Record of Decision
Former Gastown MGP Site
Tonawanda, Erie County, New York
Site Number 9-15-171

March 2007

DECLARATION STATEMENT - RECORD OF DECISION

Former Gastown MGP Inactive Hazardous Waste Disposal Site Tonawanda, Erie County, New York Site No. 9-15-171

Figure 2 - Historic Structures
Gastown MGP ROD

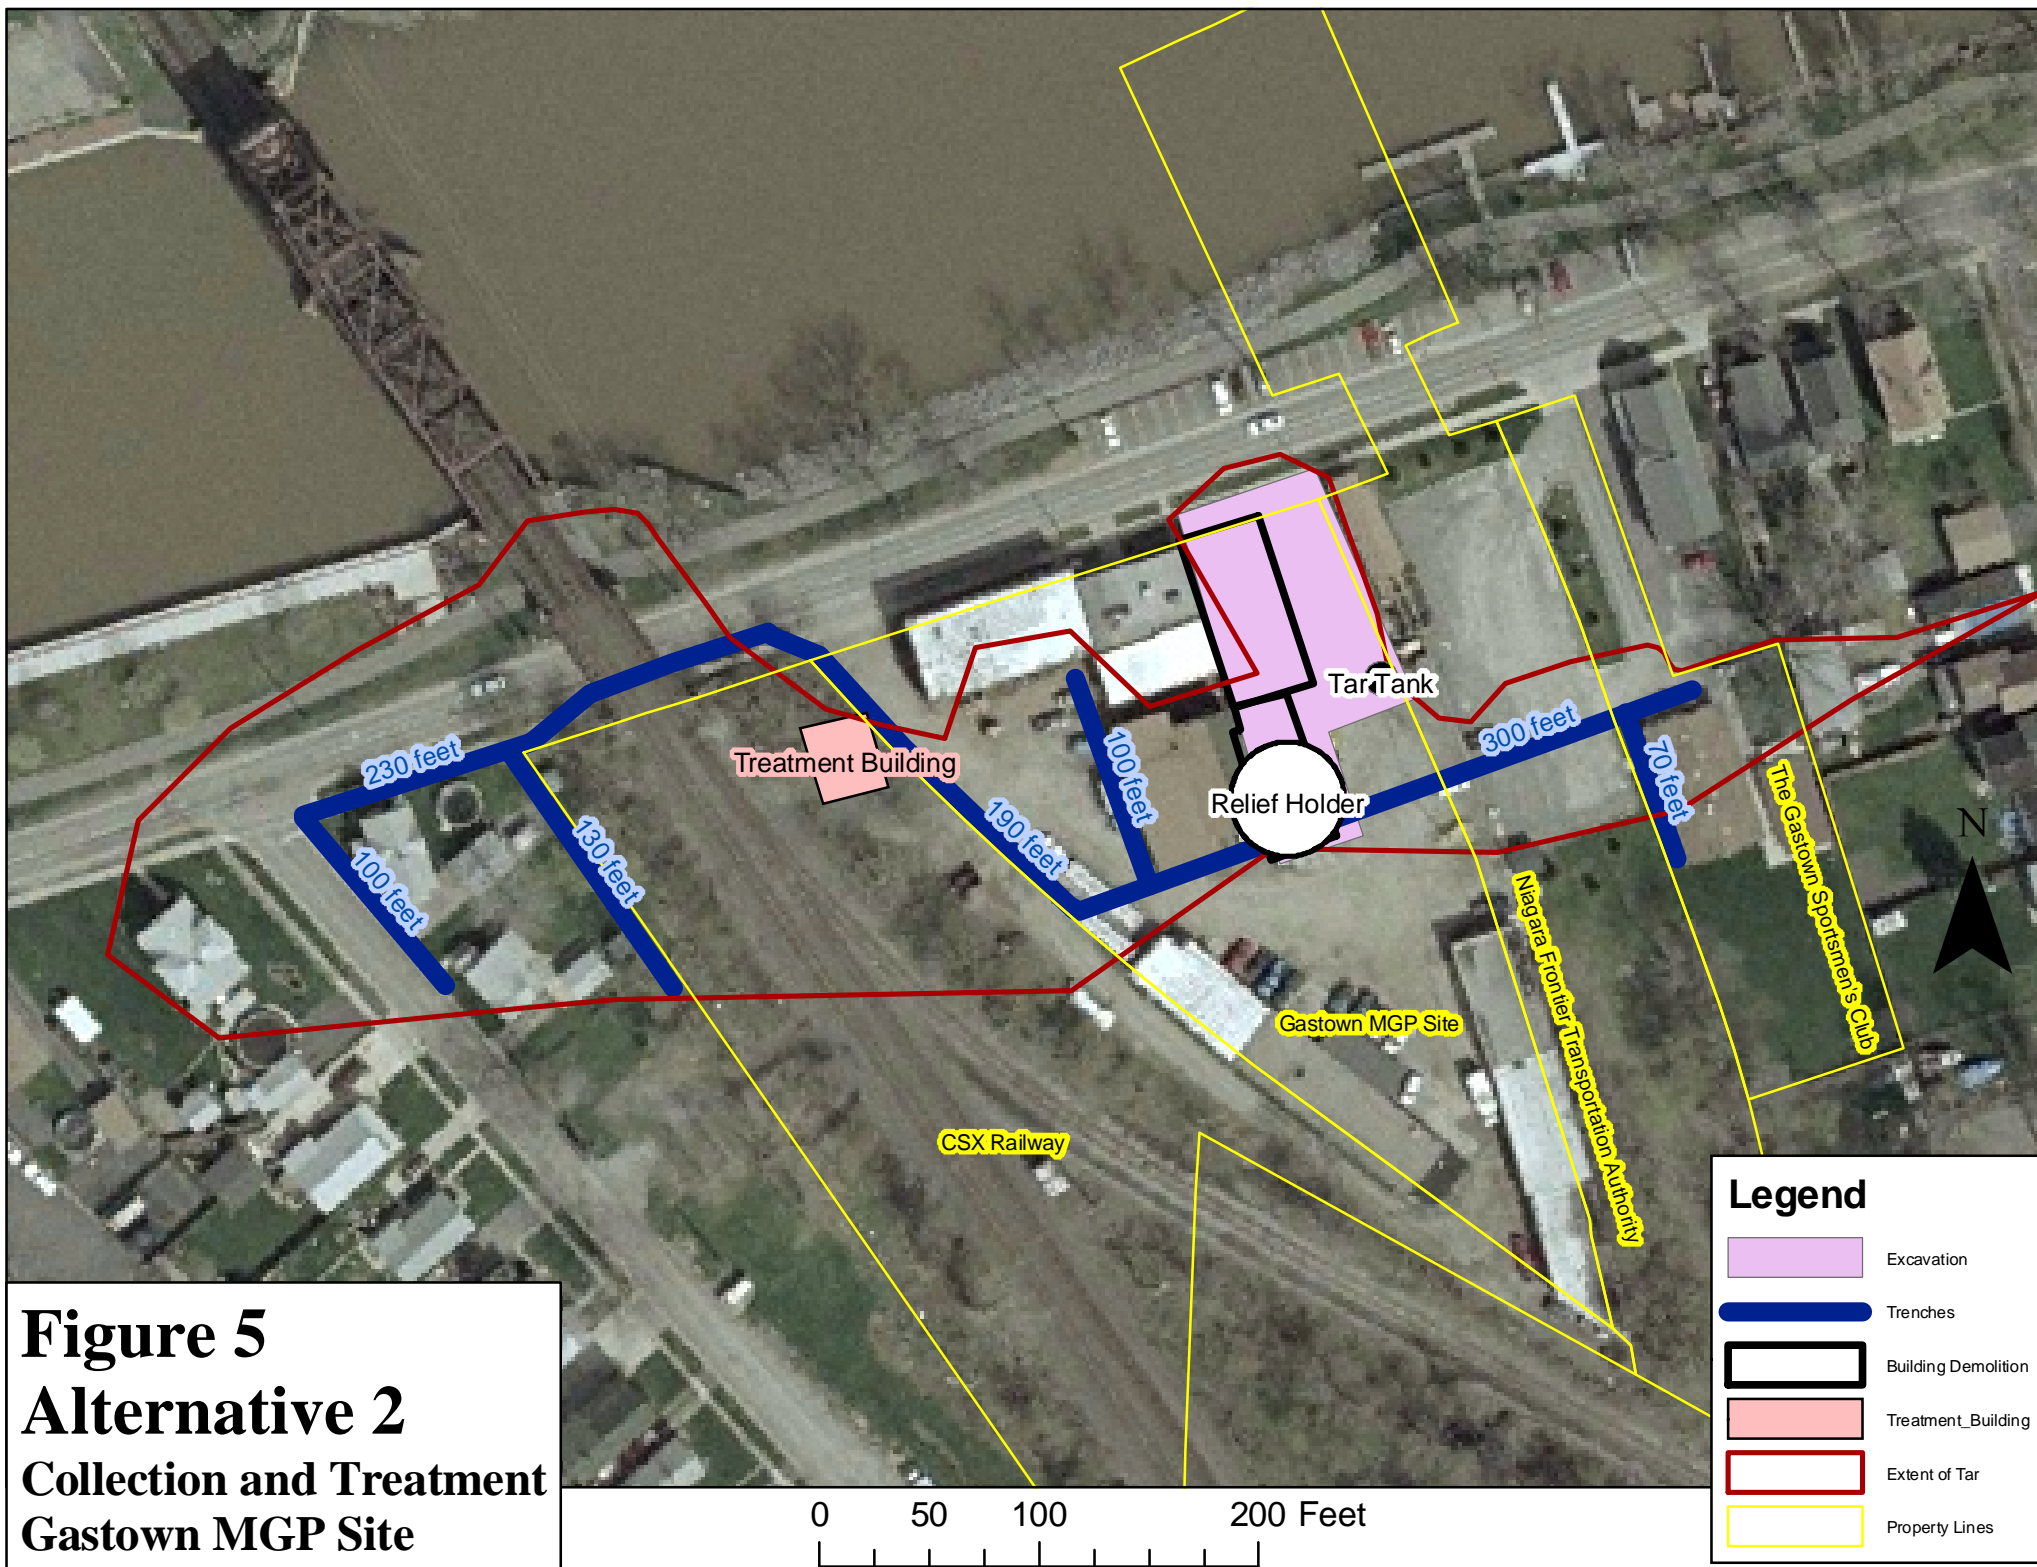
Metal Tank Removal: A buried metal tank filled with tar is located on the north east side of the site, as shown on Figure 2. It would be removed in each of the alternatives. An area of pure naphthalene crystals is located adjacent to this tank and would also be removed. The cost of this removal is estimated at \$50,000. This cost has been included in the total cost for each remedy.

Figure 8
Alternative 5
Excavation
Gastown MGP Site

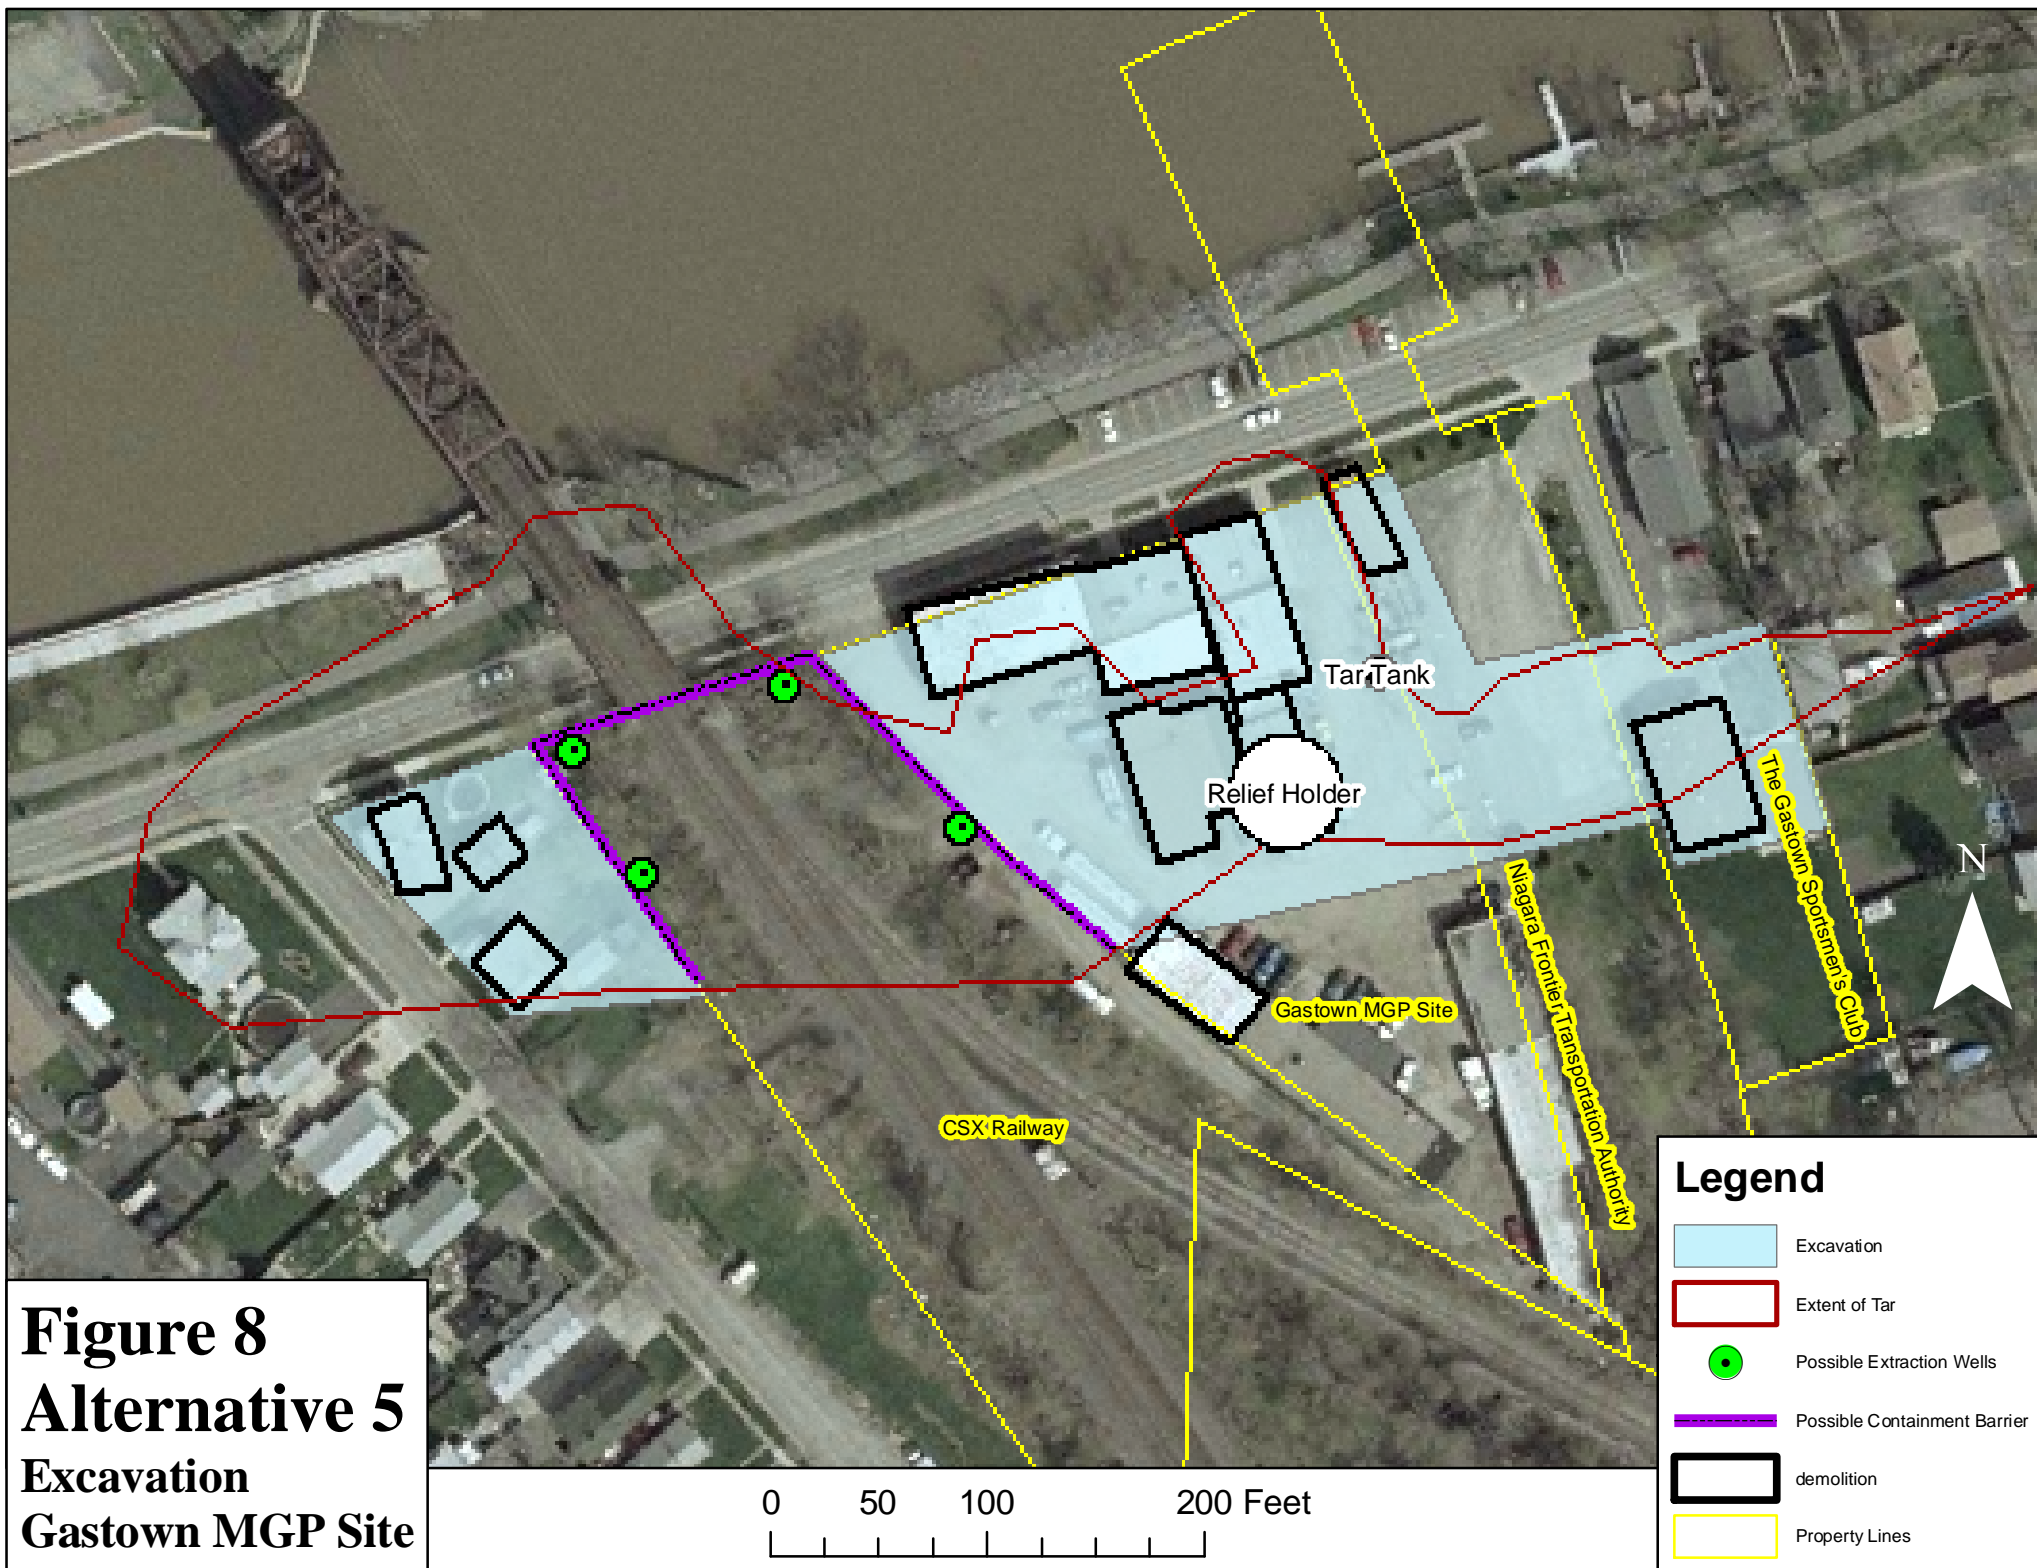
- Soils containing visible evidence of MGP tar and/or containing total PAHs greater than 500 parts per million (ppm) would be removed from the areas shown on Figure 8.

This 50,000 cubic yard excavation, shown in Figure 8, would remove NAPL-contaminated soil and soil exceeding the soil cleanup goals. Removed material would be transported off site to appropriately permitted treatment and disposal facilities. The site would then be backfilled with clean fill material.
